29 Road Interchange at I-70, NEPA/1601 Project

Meeting Name: TAC Meeting #14: CDOT Follow-up

Meeting Date: May 12, 2025

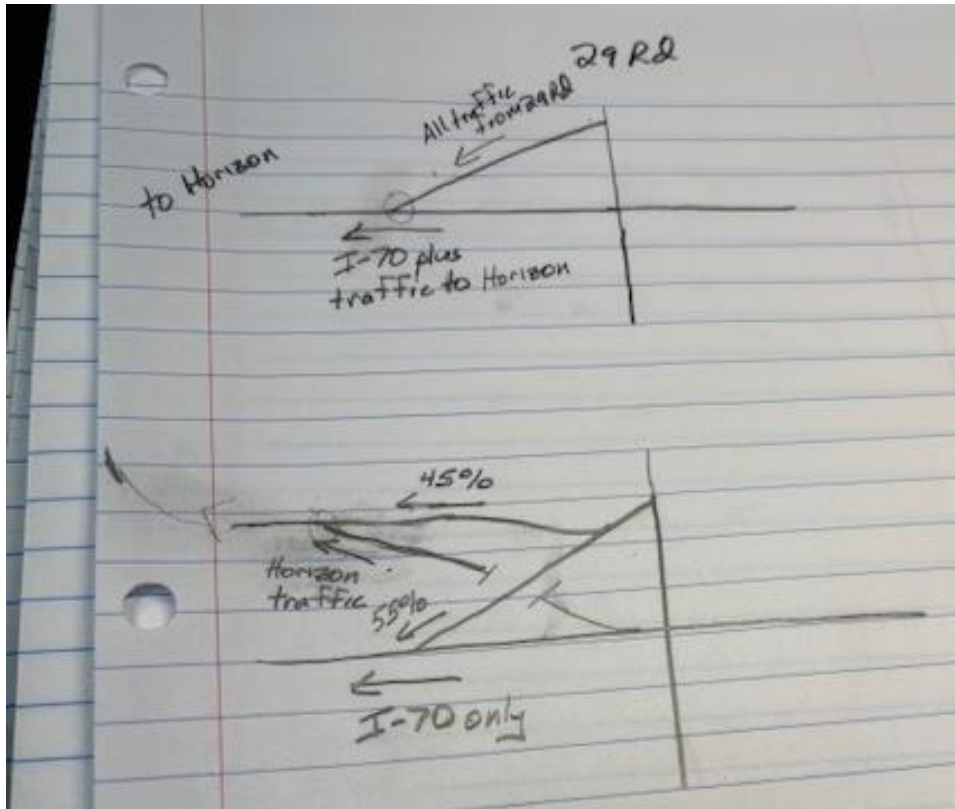
- ▶ **Question:** What is the arterial network crash rate?
 - ▶▶ **Response:** We have not yet developed a table with that information.
- ▶ **Question:** Please help me understand why the braided ramp depicts congestion while the typical ramp does not have congestion. Why would the model distribute the traffic in that manner (see drawing below)?

- ▶▶ **Post Meeting Question:** This response does not answer the question. As depicted in the hand-sketch, the base build option has one merge point (29 Rd WB on-ramp to I-70) and two lanes WB between 29 Rd and Horizon Dr. The braided ramp option has two merge points (29 Rd WB on-ramp to I-70 and Horizon Dr WB off-ramp with 29 Rd to Horizon Dr connector). In addition, there is essentially a third lane WB between 29 Rd and Horizon Dr because of the braided ramps. This means the braided ramp option has more WB capacity than the base build option so it would seem that the LOS for the braided ramps option should be

at least equal to (but not worse than) the base build option.
Please review this again to discuss it at the next TAC meeting.

- ▶▶ **Post Meeting Response:** Our analyses have consistently shown over-saturated conditions in the westbound direction. This remains true with the Build (Base) Alternative with Braided Ramp and Slip Lane scenario.

- **Post Meeting Response:** We will discuss it at the next TAC meeting.

Peak Hour I-70 Option Operations (With Mitigation)

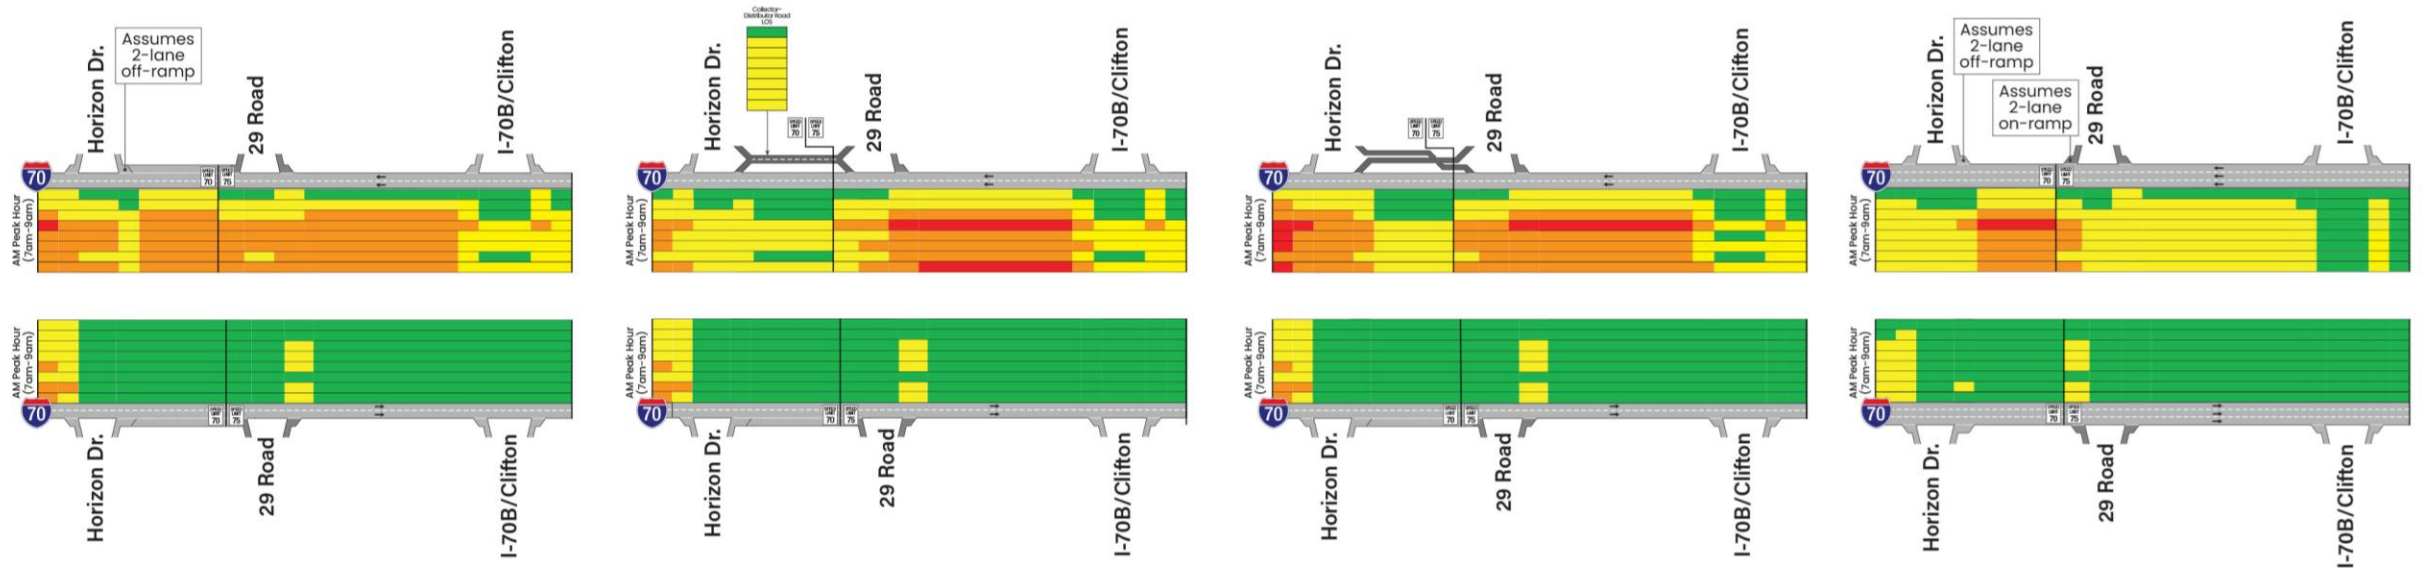
Question: Why is the 2045 AM congestion for the C-D road different than what is shown in the SLS?

Response: We would need to review the SLS and compare the tables. However, we did rerun the model for the C-D road and braided ramp scenarios. Thus, the volumes did change, which changed the levels of service. The patterns were consistent in that westbound AM.

We felt comfortable maintaining that this is similar to the SLS, but there are some changes from the SLS volumes. There was also a discussion around whether there would be connectivity between 29 Road and Horizon Drive in the braided ramp scenario which is something we've been working on and have presented results where a connection is in place to allow for traffic to exclusively go from 29 Road to Horizon Drive.

Thus, there have been multiple volume changes from what was presented in the SLS in 2024 to address what has been asked of us in the multiple TAC meetings since the draft SLS was prepared.

Shifted Interchange East

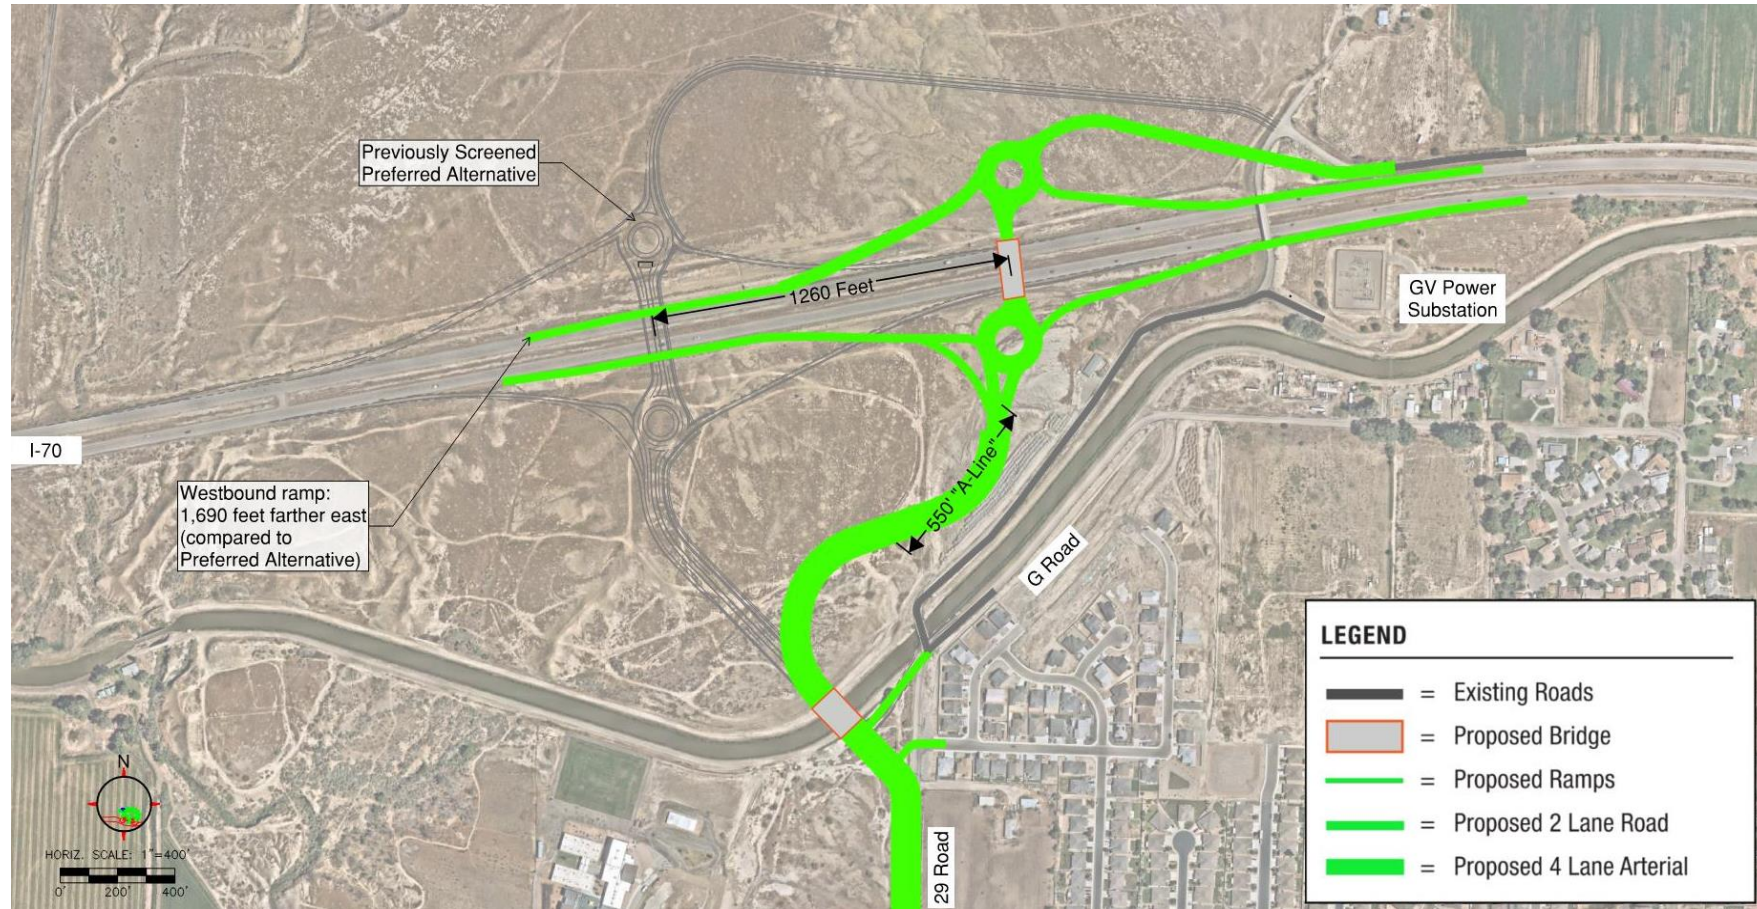
- ▶ During a previous TAC meeting, CDOT requested that we look at shifting the proposed interchange location as far east as possible to give more distance between the interchange location and the I-70 curve.
- ▶ The **westbound** 29 Road on-ramp for the revised interchange location is approximately **3,900 feet** from the I-70 curve.
- ▶ The **eastbound** 29 Road off-ramp for the revised interchange location is approximately **3,700 feet** from the I-70 curve.
